PROPOSED CHANGE RTS-181 TO THE
DUANE ARNOLD ENERGY CENTER
TECHNICAL SPECIFICATIONS

Summary

Subject: Duane Arnold Energy Center
Docket No: 50-331
Op. License No: DPR-49
Technical Specification Changes (RTS-181)
Update of NDT Operating Limit Curves
File: A-117, J-40b

Figure 3.6-1. Pressure versus Minimum Temperature Valid to Twelve Full Power Years, per Appendix G of 10CFR50

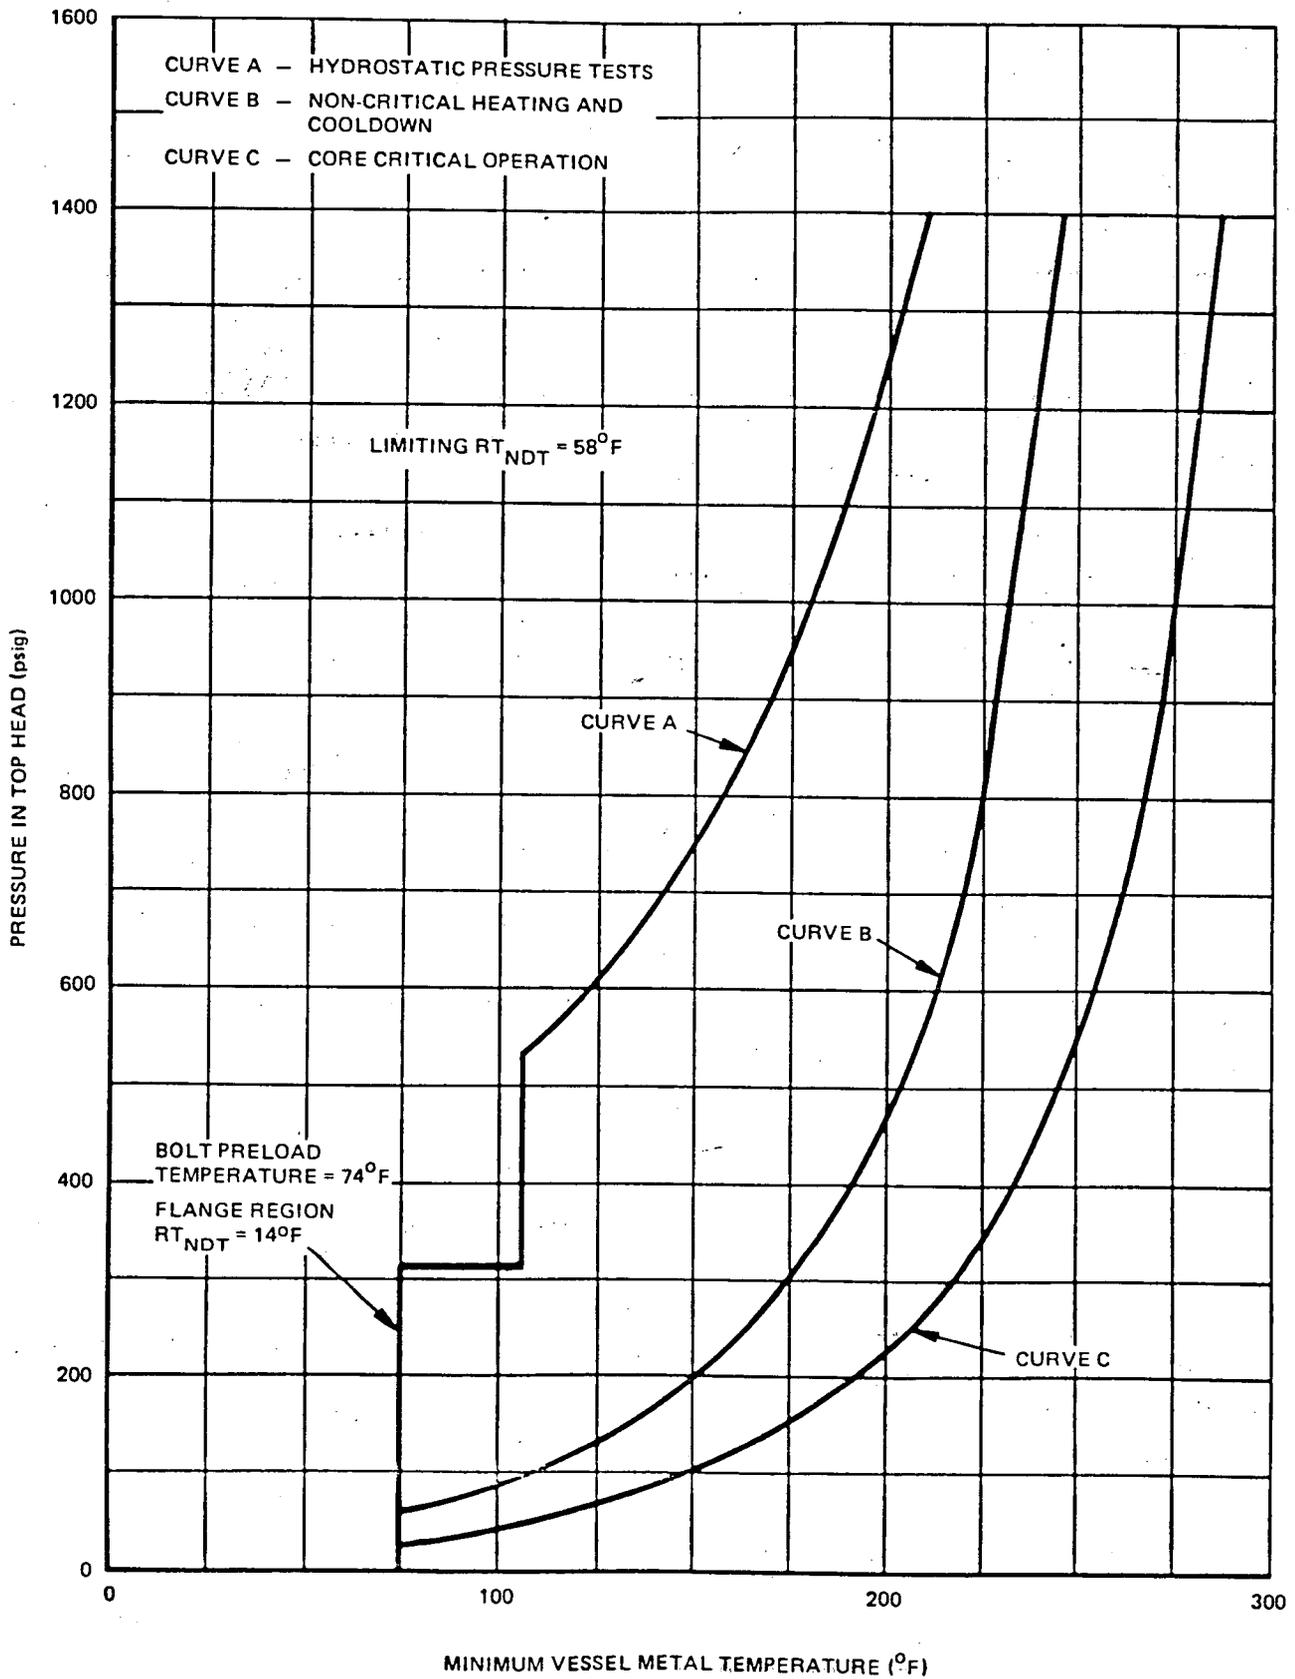
This Technical Specification change proposal updates the pressure-temperature operating limits for the Duane Arnold Energy Center reactor vessel and makes the limits valid through 12 effective full power years. The operating limits were adjusted to account for the minor estimated changes in fracture toughness due to 6 effective full power years of neutron fluence on the vessel. This update is supported by an analysis performed by General Electric which accompanies this proposal.

- 8) On page 3.6-16, the reference to the FSAR is revised to reference the Updated FSAR and the new appendix.
- 9) On pages 3.6-17 and 3.6-18, the paragraph which discusses the NDT temperature is replaced by two paragraphs which discuss the derivation of and the influences on the NDT curves and the minimum operating temperature of the closure flange region.
- 10) On page 3.6-49, the NDT curves of Figure 3.6-1 are revised to be valid through 12 effective full power years.

The operating limits in Figure 3.6-1 are derived in accordance with 10 CFR 50 Appendix G, May 1983 and Appendix G of the ASME Code. Conditions in three regions influence the curves: the closure flange region, the non-beltline region which includes most nozzles and discontinuities, and the beltline region which is irradiated with fluence above 10^{17} n/cm² during the vessel operating life. Irradiation causes an increase in the nil-ductility temperature (RT_{NDT}) of the beltline materials, possibly to the point where the beltline region impacts the pressure-temperature limits for the vessel. However, for Figure 3.6-1, effective to 12 EFPY, the beltline which has an

RT_{NDT} of $40^{\circ}F$ is less limiting than the non-beltline regions which generally experience higher stresses at nozzles and discontinuities. The limiting RT_{NDT} of $58^{\circ}F$ for the Standby Liquid Control Nozzle (N10) is the highest RT_{NDT} of any component in the non-beltline region.

Figure 3.6-1. Pressure versus Minimum Temperature Valid to Twelve Full Power Years, per Appendix G of 10CFR50

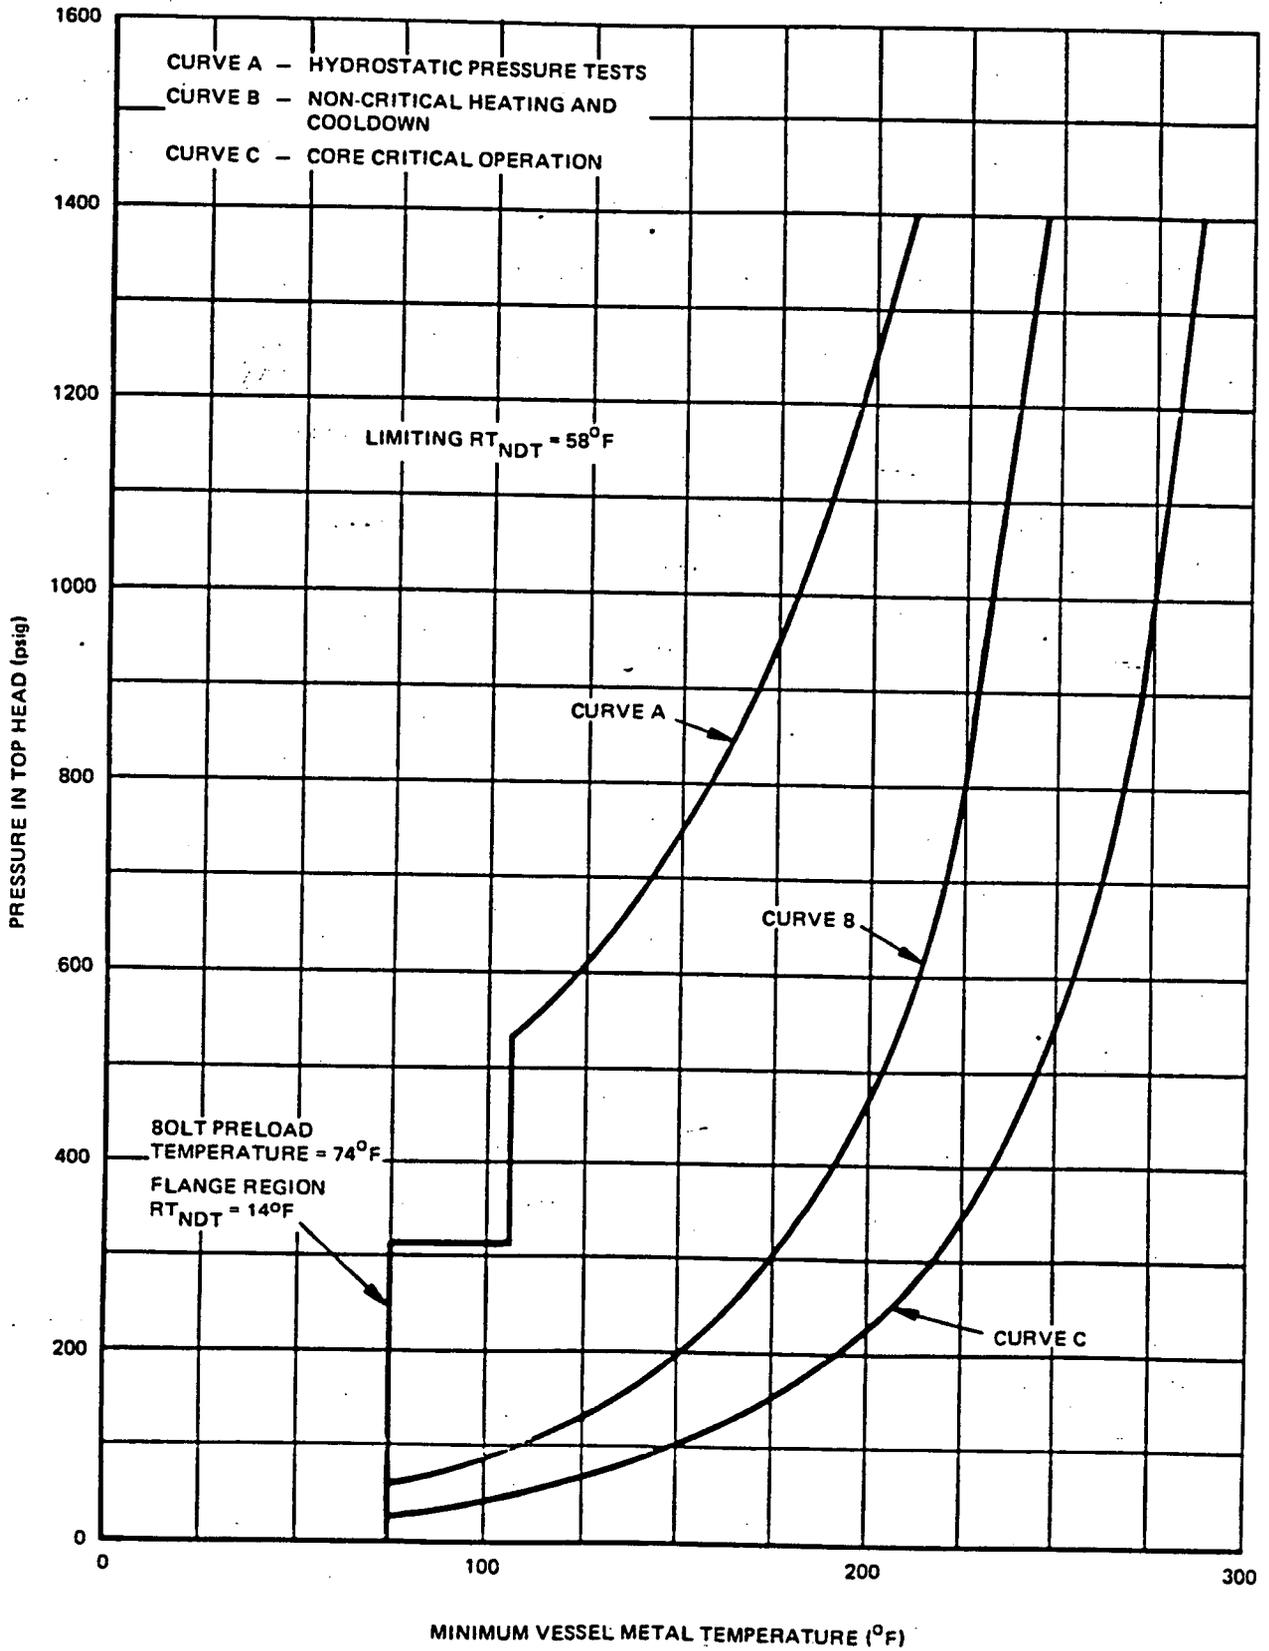
This Technical Specification change proposal updates the pressure-temperature operating limits for the Duane Arnold Energy Center reactor vessel and makes the limits valid through 12 effective full power years. The operating limits were adjusted to account for the minor estimated changes in fracture toughness due to 6 effective full power years of neutron fluence on the vessel. This update is supported by an analysis performed by General Electric which accompanies this proposal.

- 8) On page 3.6-16, the reference to the FSAR is revised to reference the Updated FSAR and the new appendix.
- 9) On pages 3.6-17 and 3.6-18, the paragraph which discusses the NDT temperature is replaced by two paragraphs which discuss the derivation of and the influences on the NDT curves and the minimum operating temperature of the closure flange region.
- 10) On page 3.6-49, the NDT curves of Figure 3.6-1 are revised to be valid through 12 effective full power years.

The operating limits in Figure 3.6-1 are derived in accordance with 10 CFR 50 Appendix G, May 1983 and Appendix G of the ASME Code. Conditions in three regions influence the curves: the closure flange region, the non-beltline region which includes most nozzles and discontinuities, and the beltline region which is irradiated with fluence above 10^{17} n/cm² during the vessel operating life. Irradiation causes an increase in the nil-ductility temperature (RT_{NDT}) of the beltline materials, possibly to the point where the beltline region impacts the pressure-temperature limits for the vessel. However, for Figure 3.6-1, effective to 12 EFPY, the beltline which has an

RT_{NDT} of 40°F is less limiting than the non-beltline regions which generally experience higher stresses at nozzles and discontinuities. The limiting RT_{NDT} of 58°F for the Standby Liquid Control Nozzle (N10) is the highest RT_{NDT} of any component in the non-beltline region.
